Saab 9-3 - Loss of coolant | HELLA

Engine code: B284.

Chassis no. : 61000001 – 81107480.

Loss of coolant

Figure 1

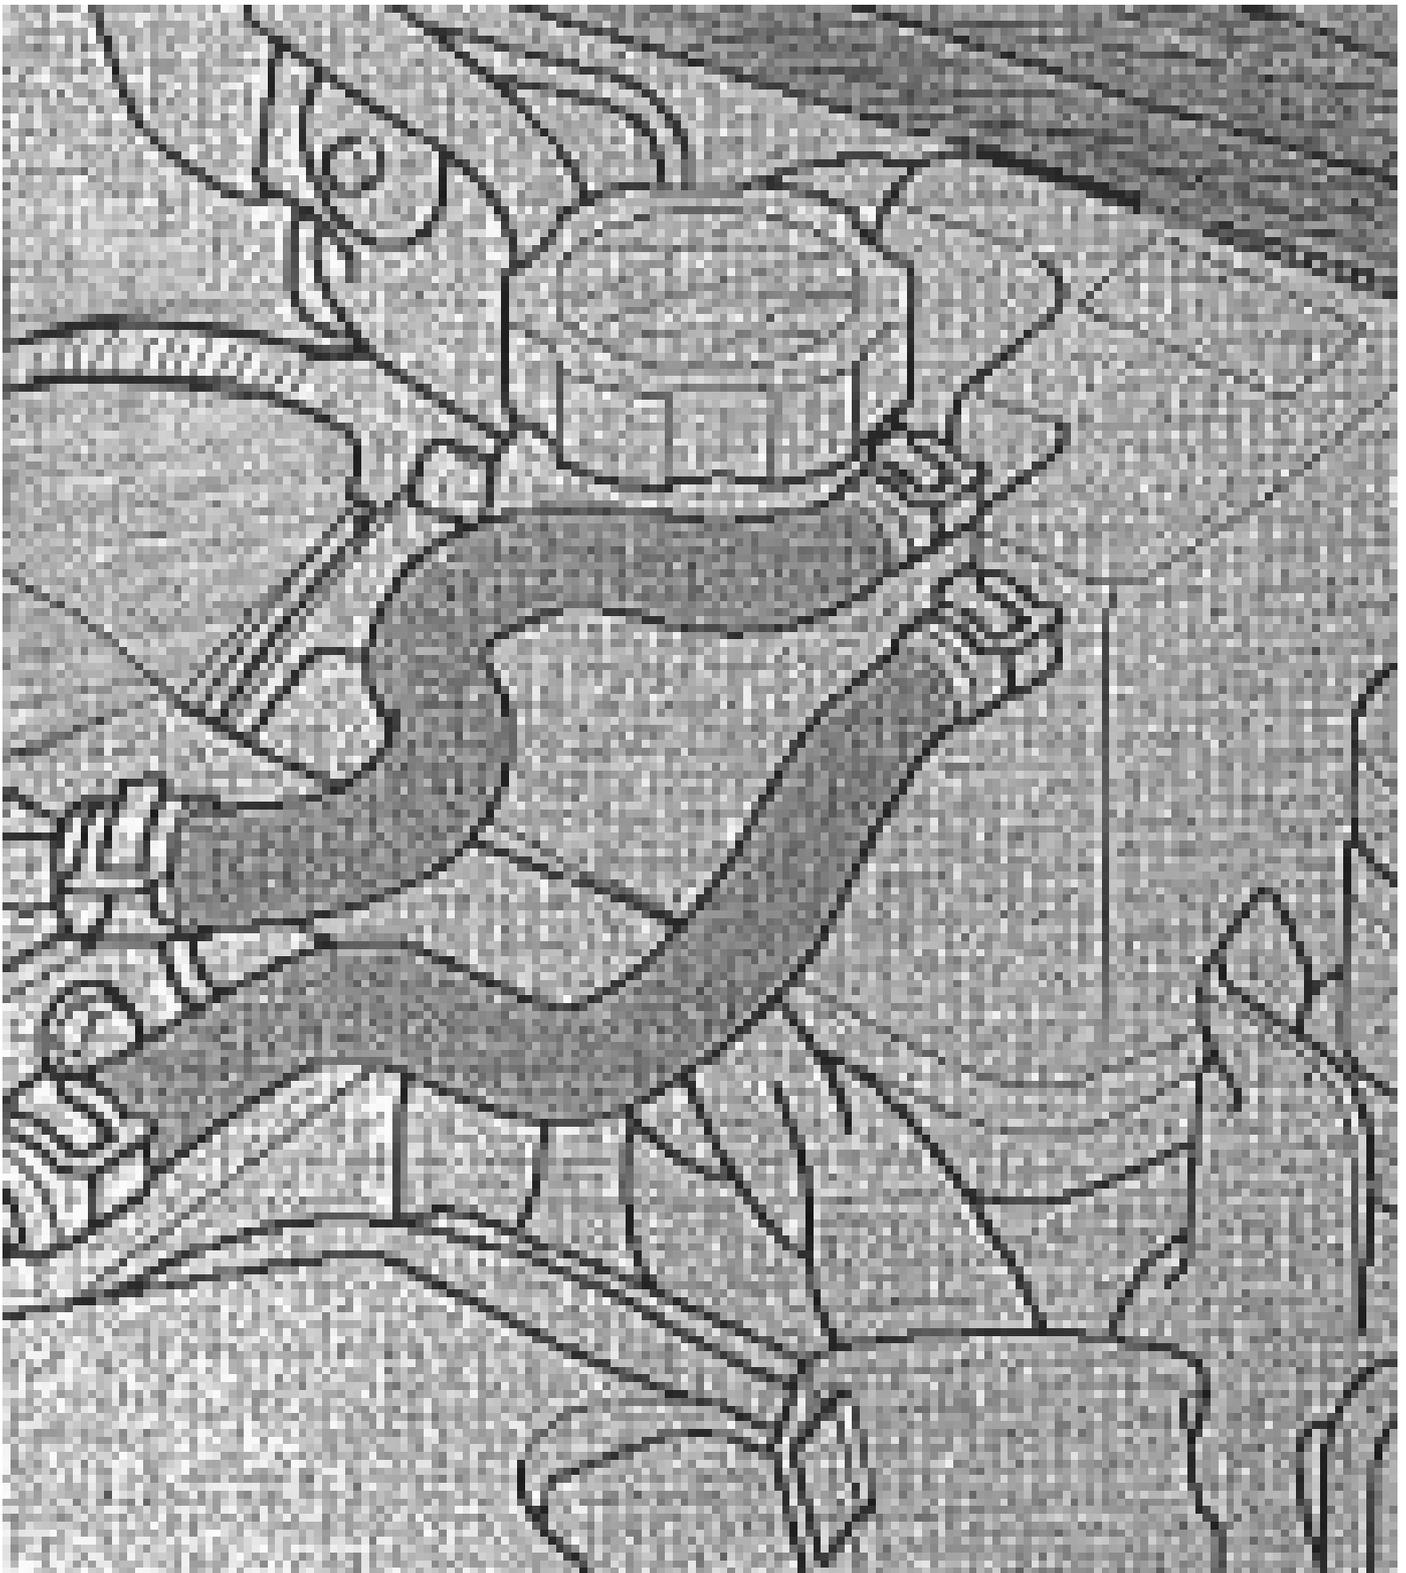
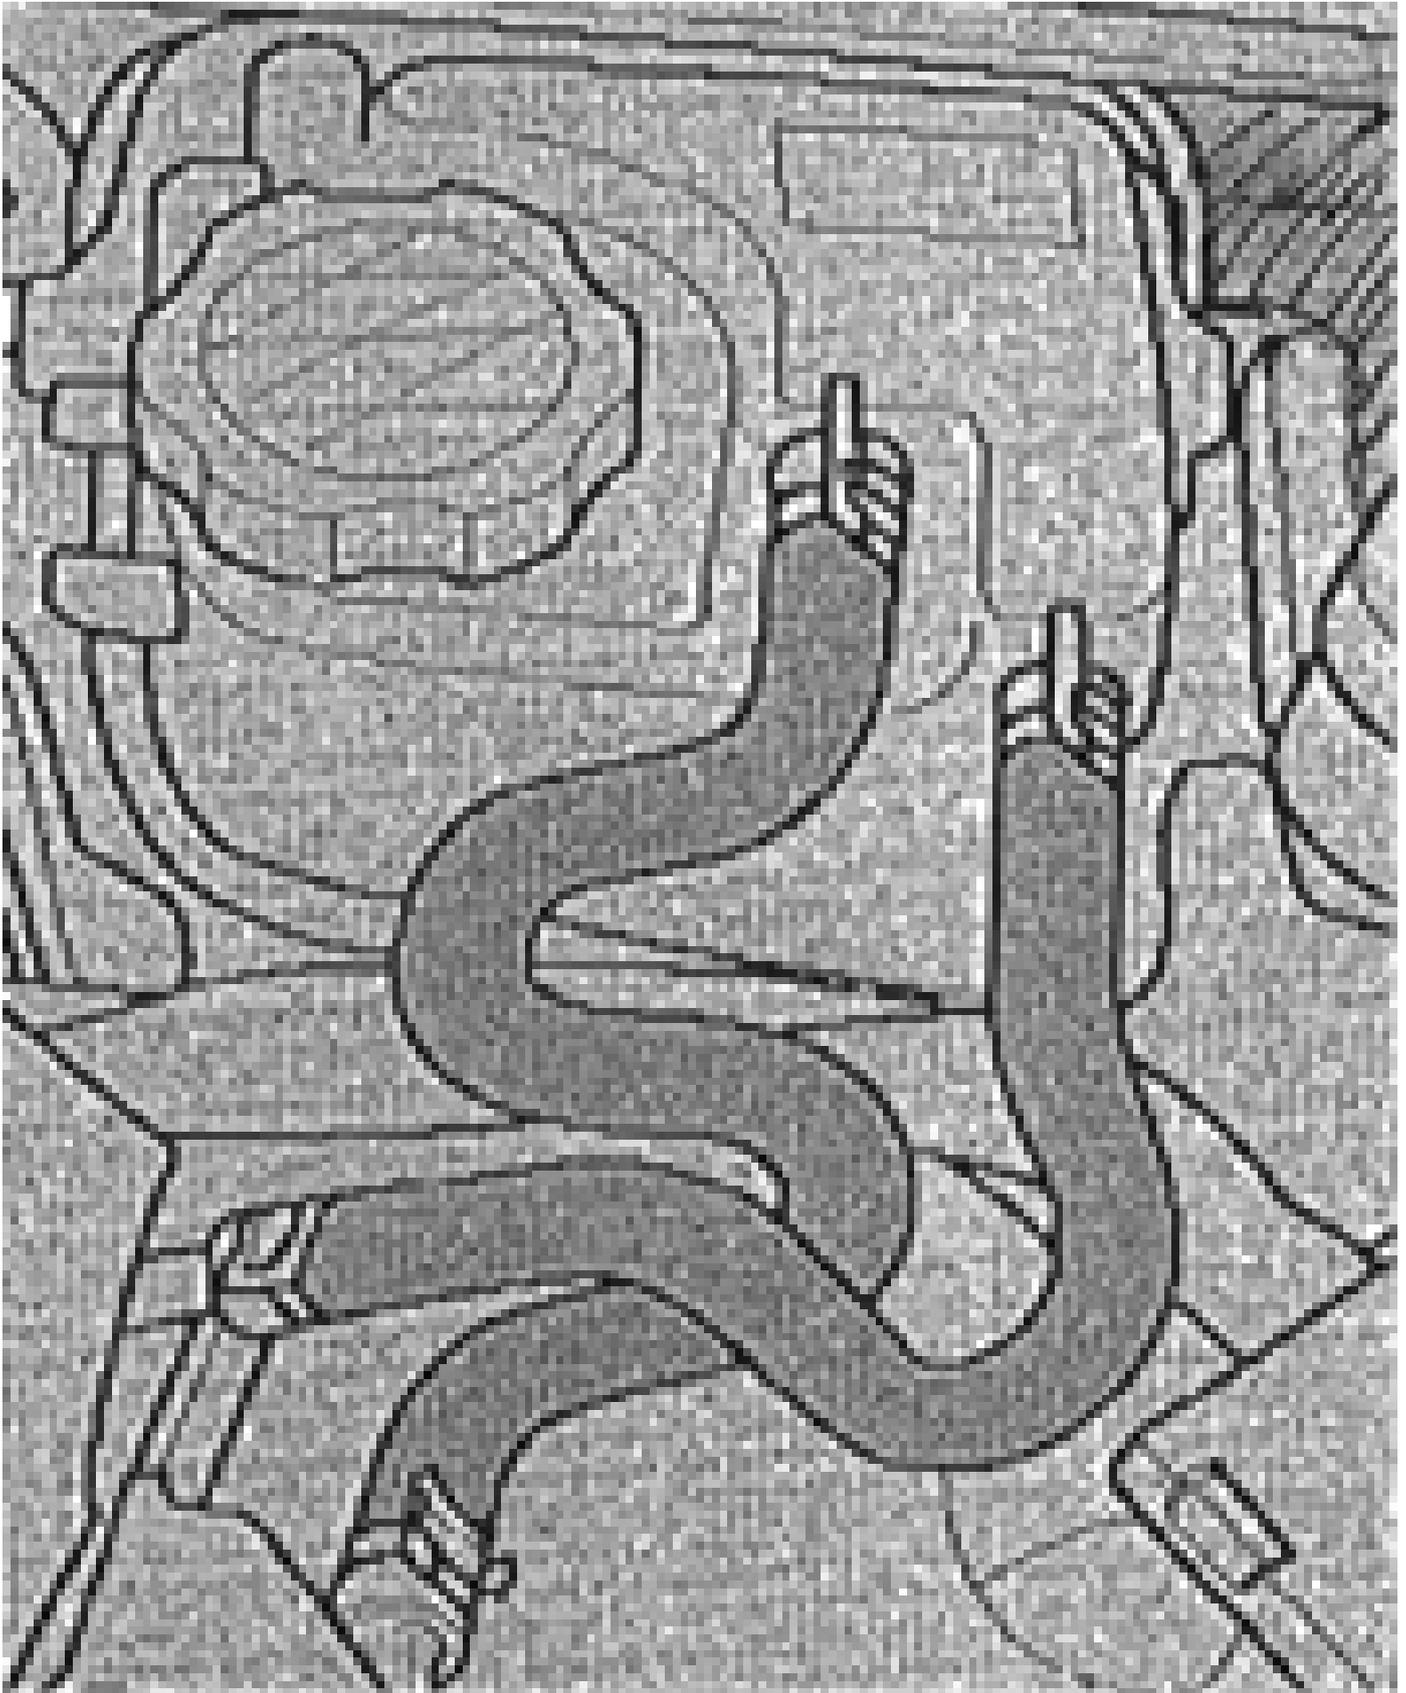
In the case of the above-mentioned vehicles, problems can arise because of loss of coolant. The cause of this can either be a defective coolant expansion tank or damaged engine coolant hoses on the coolant expansion tank.

(Modified layout)
